# Public Service Commission

The Reclamation Division has completed a technical review of the application for Bond Release No. 3 to Permit NAFK-9601. The following items were noted in that review and must be corrected prior to approval:

### **Attachment VII – Regraded...Map**

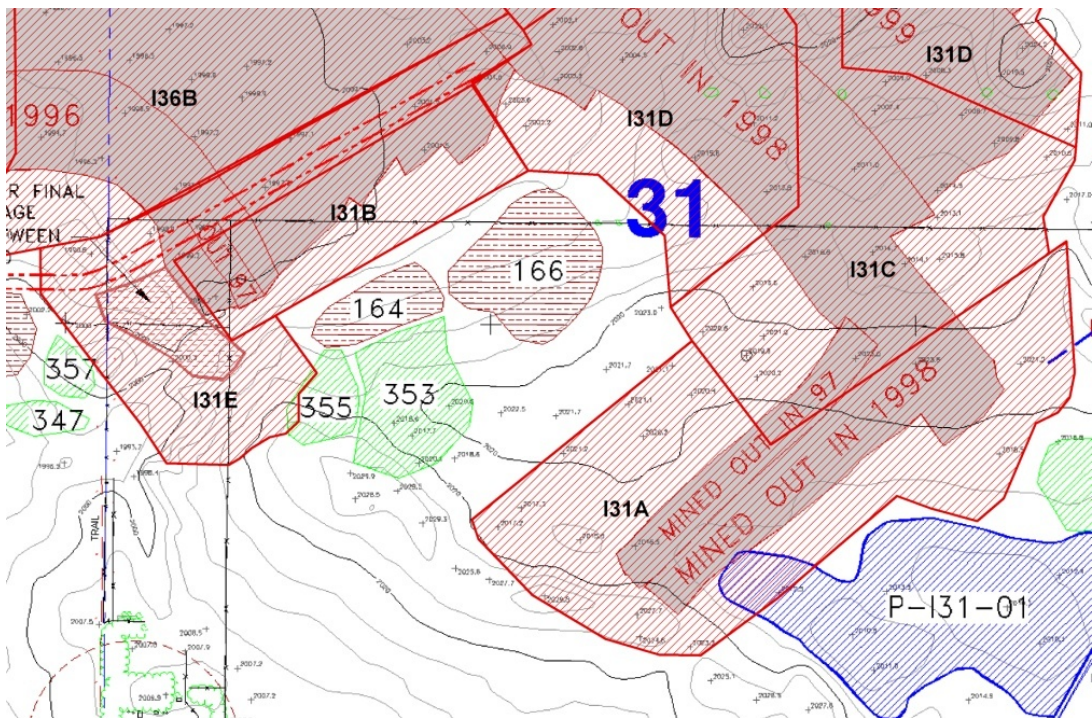
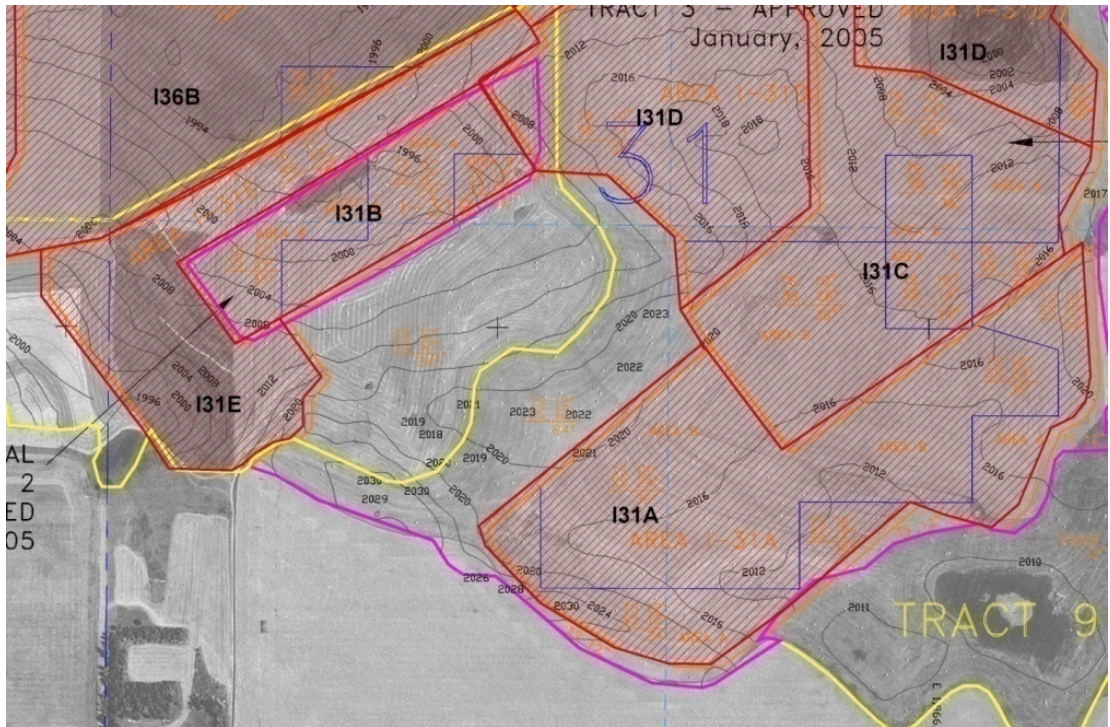
6. The contour lines on Attachment VII should extend 500 to 1000 feet beyond the disturbance boundary (of the bond release tracts) to clearly illustrate how the reclamation will tie into the adjacent undisturbed land. (MSK)

7. Please make the following corrections to the map submitted with the bond release application (most of the corrections have already been made to successive updated versions of the map provided to Bill Gunnerson, the most recent of which was submitted to the PSC via email on July 28, 2009):

- a) Please correct the SPGM respread depth labels for grade approval area I-25C to read 11 inches of topsoil and 13 inches of subsoil as described in the September 21, 2004 grade approval request and the October 15, 2004 approval letter.

- b) Please correct the SPGM respread depth labels for Tracts 8 and 9 to read 12 inches of topsoil only because these tracts were areas of associated disturbance used for stockpiles and a sedimentation pond. Also, please add a SPGM respread depth label of 11 inches of topsoil only to an unlabeled area of associated disturbance used for stockpiles in the NW¼ of Section 30 of Tract 7.

- c) Please illustrate and label the 2.77 acre parcel of reclaimed prime farmland in the SE¼ of Section 36 as described in Section 2.8.1 - Soils and Prime Farmland Narrative and shown on Section 4.1.2 - Post-Mining Land Use Map of the permit.

- d) Please add a soil respread thickness boundary (blue line) to separate the Sheldon property in the S½ of the NE¼ of Section 30 from the Falkirk property in the remaining portion of grade approval I-30C in Tract 7. Also please add a SPGM respread depth of 12 inches of topsoil and 12 inches of subsoil to the Sheldon property as described in the November 30, 2005 grade approval request.

- e) Based on a review of grade approvals for Permit NAFK-9601, and Section 3.1.5 - Pit Layout and Facilities Map of the permit, it appears that a parcel of approximately 50 acres in Section 31 bounded by grade approval areas I-31A, I-31C, I-31D, I-31B, and I-31E, should be labeled as requiring respread of 12 inches of topsoil only because it is an area of associated disturbance. As shown on the images below, the area is labeled as 12 inches each of topsoil and subsoil respread, but was not included in a

grade approval because it was used as a location for SPGM stockpiles. Part of the area is in Tract 7 of Partial Bond Release No. 3, while the remaining area received partial bond release in January 2005. Soil probing in the area included with Tract 7 indicated that the area was an associated disturbance. Please review the SPGM thickness that was respread for this area, and correct the labeling if necessary. (WTG)
